## M4 Junction 48 and A4138

### WelTAG Appraisal (Stage 3) – The Transport Case (Addendum)

The Welsh Government's (WG) South Wales Trunk Road Agent (SWTRA) has commissioned Atkins to produce an Addendum to the M4 Junction 48 (J48) and A4138 Pontarddulais Road WeITAG Stage 3 Appraisal (October 2018) to reflect modifications to the preferred option.

Figure 2-2 Scheme Detailed Design (Modified)

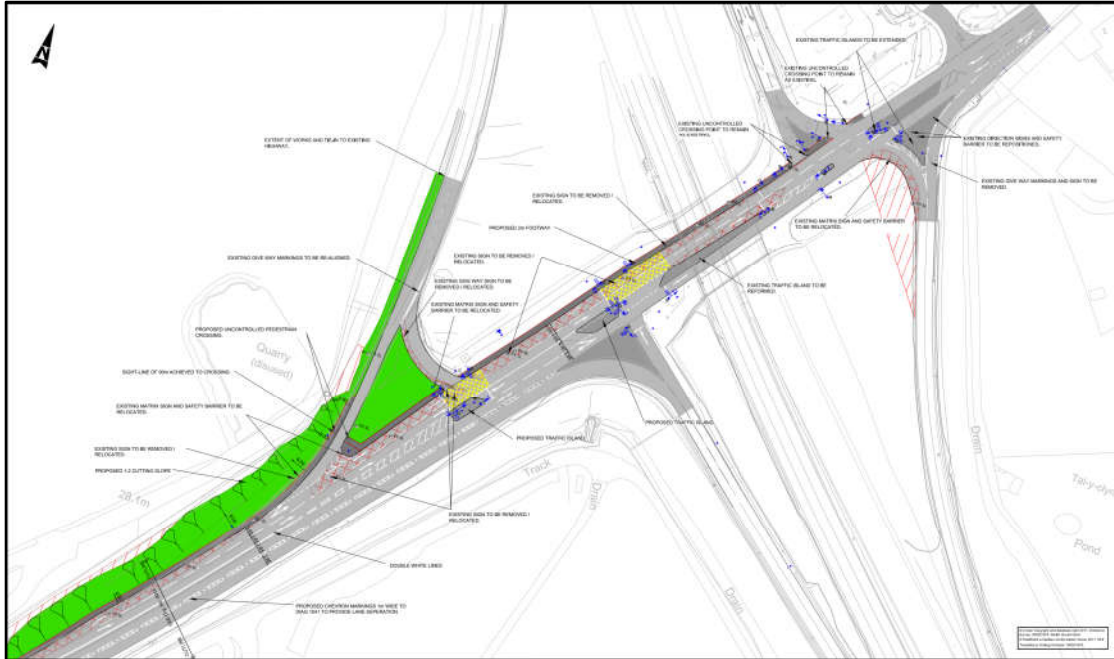
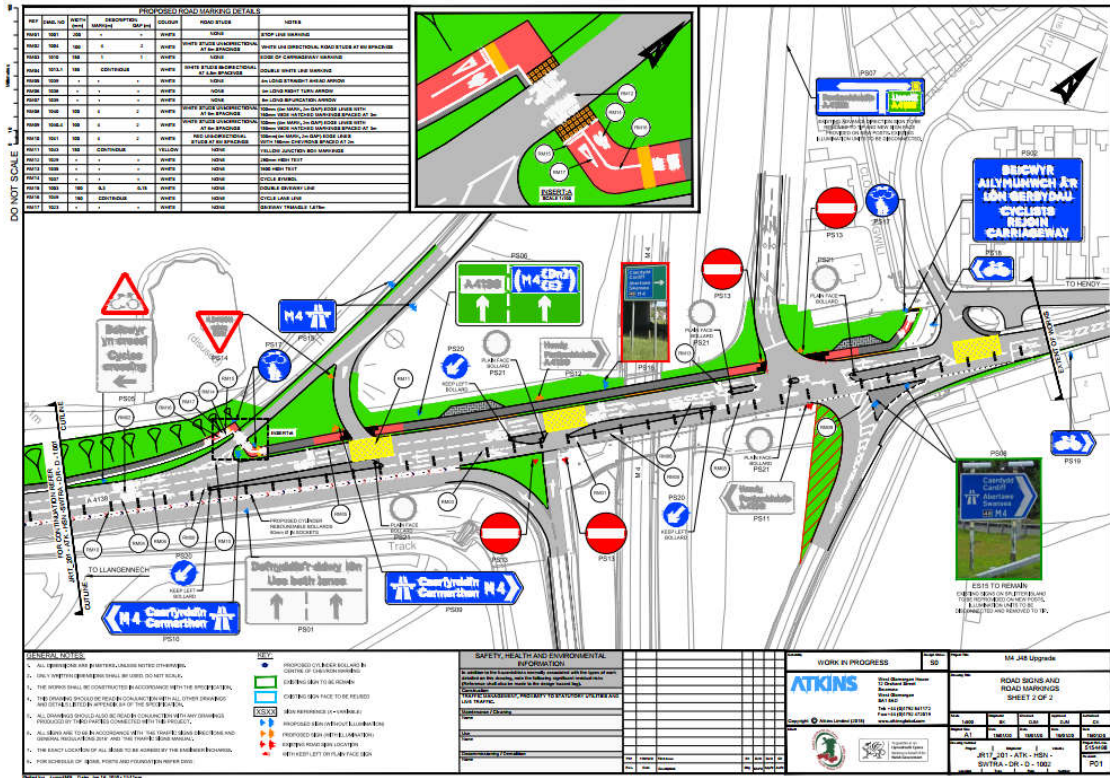
Following comments from key stakeholders, the preferred option (Option 2a) retained from the Stage 2 Appraisal has been amended as follows:

- The signalisation of the A4138 / Tal-Y-Coed junction;
- In reference to INM H6 (which is an aspirational Shared Use Route connecting Hendy and Llangennech), the upgrading of the northbound footway to a Shared Use Path; and
- The introduction of Toucan Crossings (at the proposed signal controlled junctions).

### APPENDIX C: Current Stage 1 RSA Location Plans

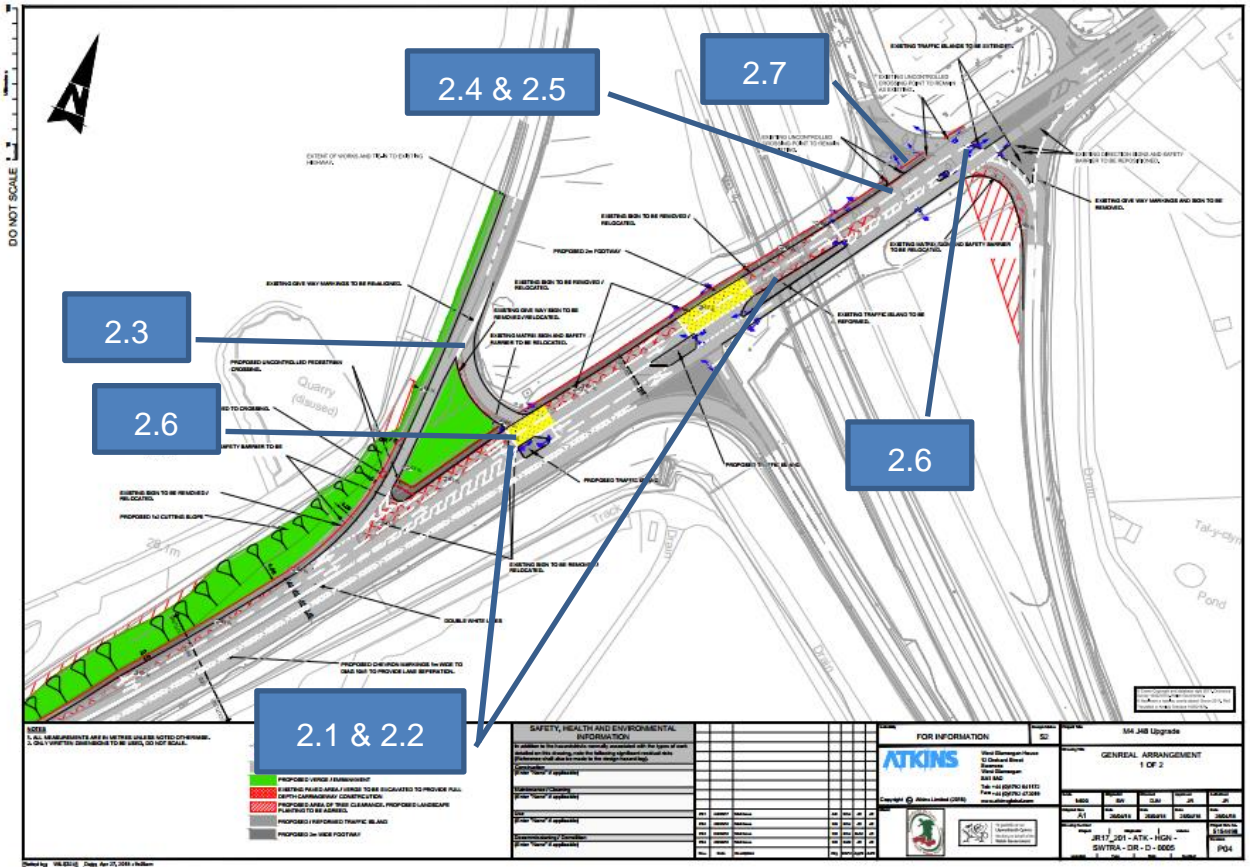
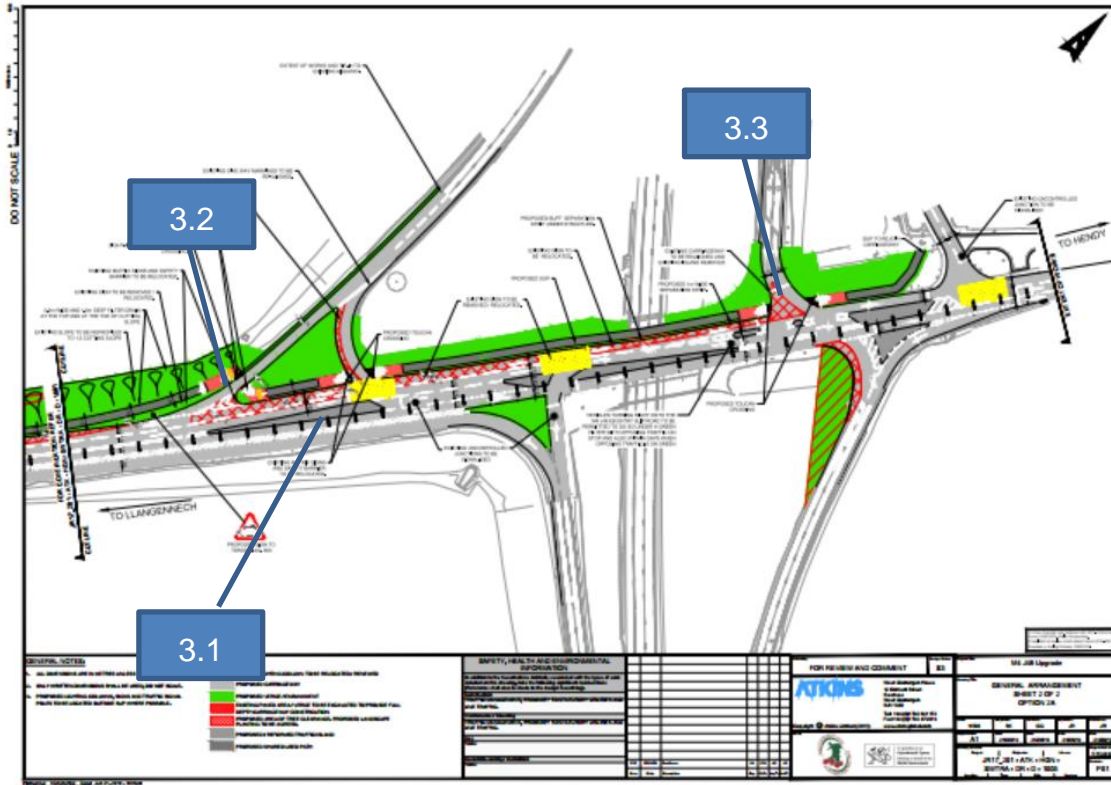
*The new designs show an additional set of traffic signals, which may lead to a greater likelihood of 'see-through' of downstream traffic signals.*

*Response acknowledges the problem and identifies design features that could help to mitigate the problem if included in the scheme. Mirroring the design of the eastbound onslip at this location where two lanes run side-by-side may further mitigate this problem.*

The junctions at the end of the westbound off-slip and on-slip both currently have yellow box markings and this would be retained (in a different layout) in the proposals. The introduction of two new sets of traffic signals could change the nature of queuing at the junction. It is not clear if a yellow box marking is required for the traffic signal junction at the end of the eastbound off-slip but, in the event of queuing across the junction on the A4138, a queue could build up on the off-slip reaching back to the main carriageway. The queue could then lead to a collision between stationary vehicles and high-speed main carriageway traffic.

The proposals include the removal of part of a traffic island that currently separates opposing directions of traffic on the A4138. The existing traffic island guides right-turning users into the correct lane but, with the removal of a significant section of the island, unfamiliar users may mistakenly pass to the right of the island where there would be two lanes. This could lead to a collision with oncoming vehicles.

*Noted - Additional louvres could be added to the green and amber signal aspects, if required to help minimise the issue of 'see through' on the first 2 sets of traffic signals on the A4138 north-eastbound approach. The 69m distance between the first and second stop line is normally considered sufficient that they will not be required on the second set. The 59m between the second and third stop line may justify louvres on the third set, although it is hoped the phasing/ staging arrangement will negate the need for the louvres, with drivers not seeing a downstream green when held on a red signal.*

*Agreed – The visibility at the give way line to vehicles approaching from the left will be improved by the proposed on-slip carriageway realignment and proposed wider verges behind the footways. Street furniture in the splitter island will be reviewed and relocated as required to provide better visibilities to vehicles approaching and waiting at the give way line.*

*Right turn onto eastbound onslip: a separate filter phase would provide improved safety and remove the potential for conflict between vehicles in opposing directions.*

*Right turn onto westbound onslip: the revised drawing indicates that the design will include a separate right turn filter phase which will remove the potential for conflict.*
